Project Name Choctaw Point Container Terminal – Phase V Dock Extension

ADDENDUM NO. 4

**11411- Task 6 – Choctaw Point Container Terminal – Phase V Dock
Extension
Contractor Questions
Addendum No. 4**

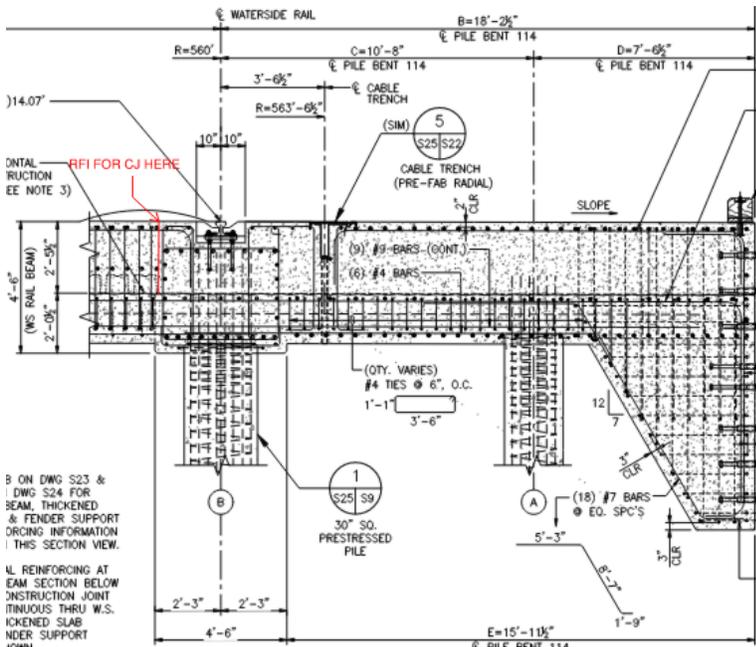
- No dredging is required.
13. Drawing S25. Clarify if below detail for construction joint is acceptable to maintain the same elevation of the initial concrete pour across the entire area:

- No, the construction joint is to be as shown.

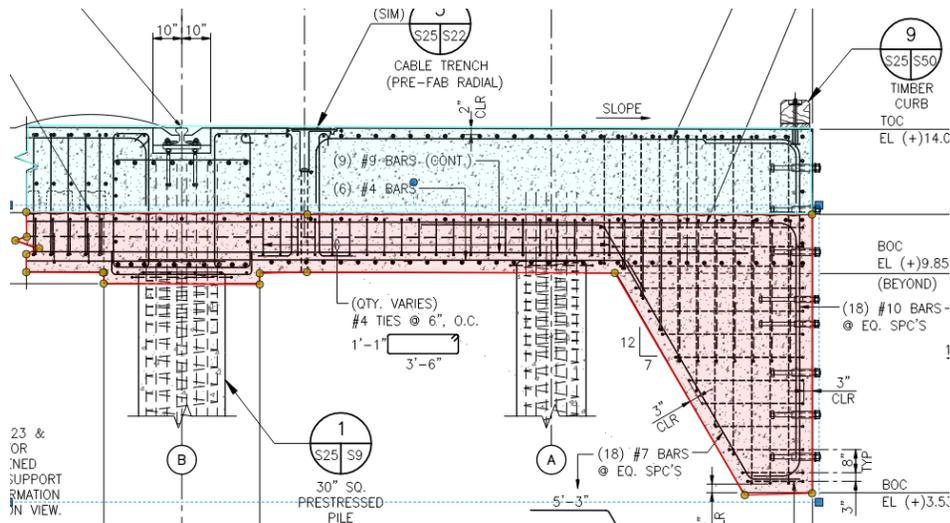
14. Drawing S25. Clarify if below detail for construction joint is acceptable to allow secondary concrete pour waterside of crane rail:

- No.

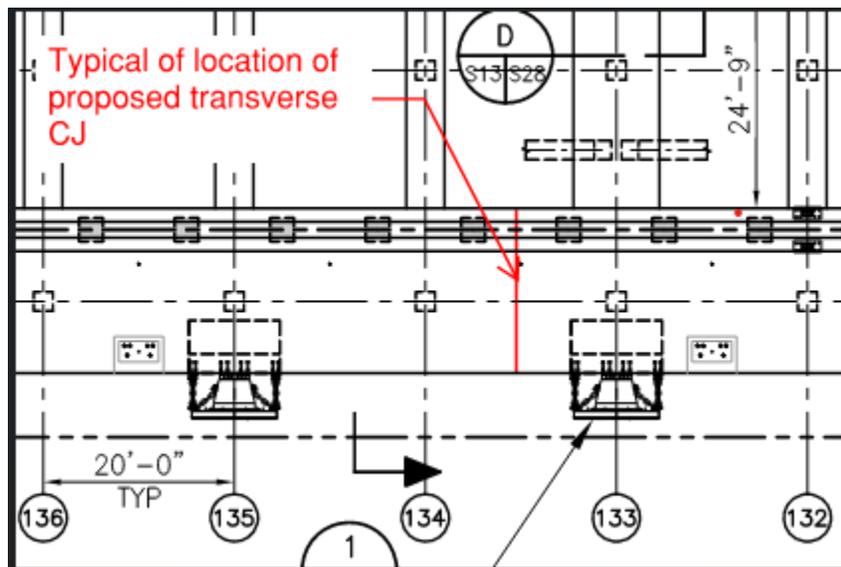
27. Please provide specs for the MV switchgear or the E-house for the 22.9 kV gear.

There are notes on drawing 131 that reference the Eaton as built towards the end of the drawing package, but we could not find any specs.

- See specification 261000 included in this addendum.

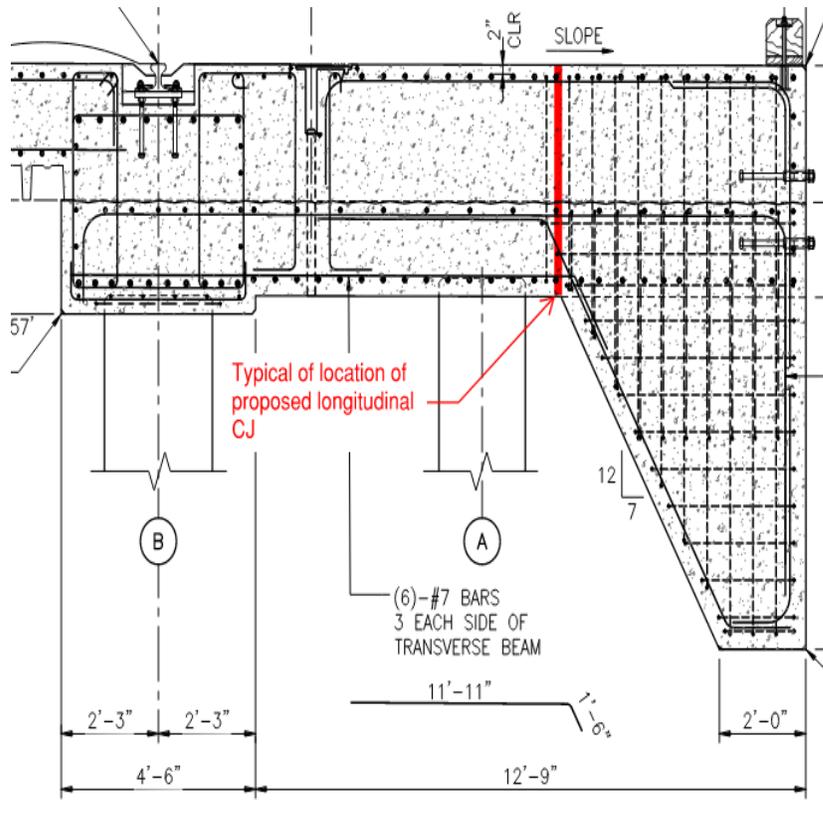
30. Will a longitudinal construction joint be allowed between pile line A and the haunch?

- No.

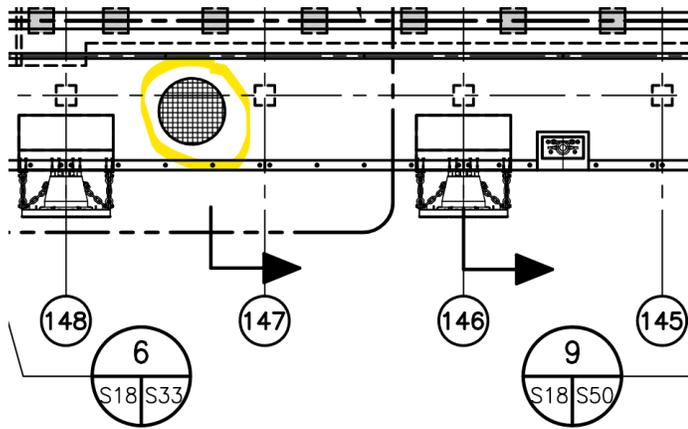
31. SECTION 111313 – FENDER SYSTEM. Regarding the testing requirements in 3.6.4: *All testing must be conducted in the United States of America and shall either be witnessed by a recognized accreditation agency such as Lloyds Register or conducted by a 3rd party independent laboratory. Velocity corrections will not be allowed nor will scale model tests be allowed as an alternative. The Port Authority reserves the right to retest selected fender elements.* Question: Is "all testing" mentioned in 3.6.4 above related to 3.6.1 (20% of supplied fenders), or is this for all fenders supplied?

- 20% of supplied fenders
